Approved Final Butte Priority Soils Operable Unit (BPSOU) Unreclaimed Sites Field Sampling Plan (FSP) Package #7: UR-01, UR-12, UR-03, UR-04, UR-15, and UR-17

RE: Response to Comments to the Butte Priority Soils Operable Unit (BPSOU) Unreclaimed Sites Draft Final Field Sampling Plan (FSP) Package #7: UR-01, UR-12, UR-03, UR-04, UR-15, and UR-17

**Butte Priority Soils Operable Unit (BPSOU) Unreclaimed Sites Final Field Sampling Plan (FSP)
Package #7: UR-01, UR-02, UR-03, UR-04, UR-15, and UR-17**

DATE: 10/2021

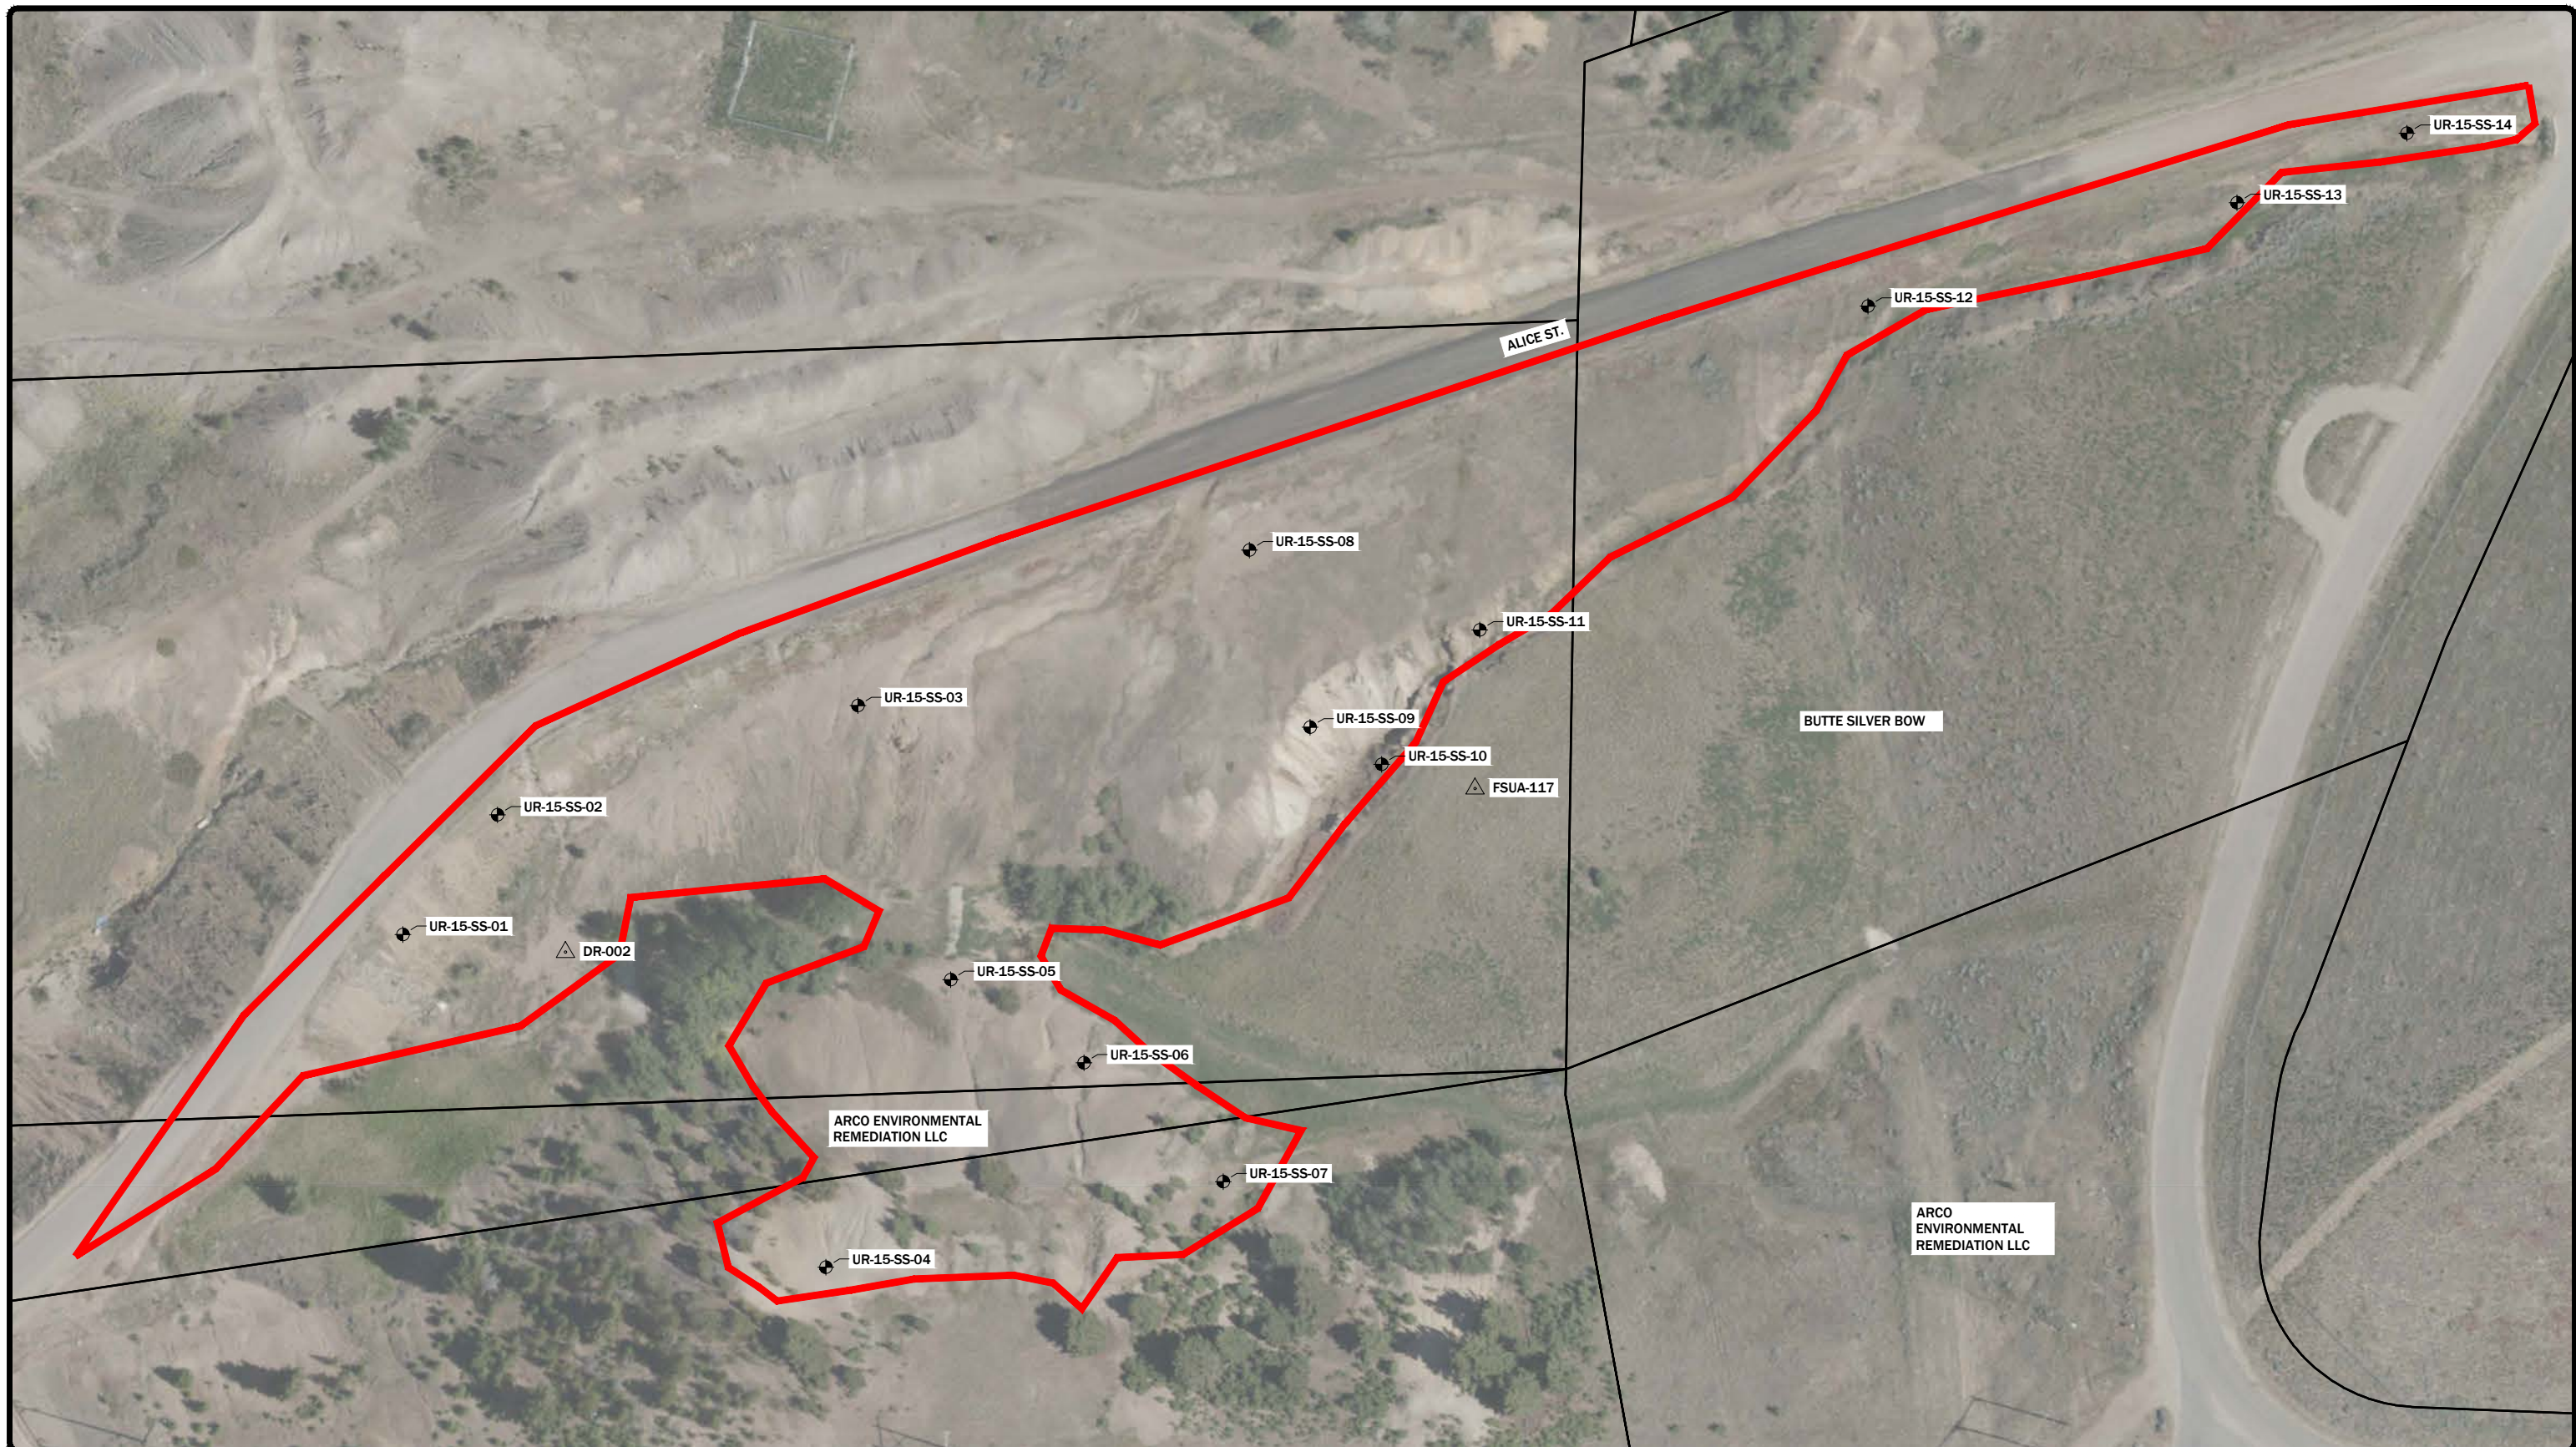
Please remove the private property owner names or business names from all figures.

Atlantic Richfield Response: Private property ownership and business names have been removed from figures and text.
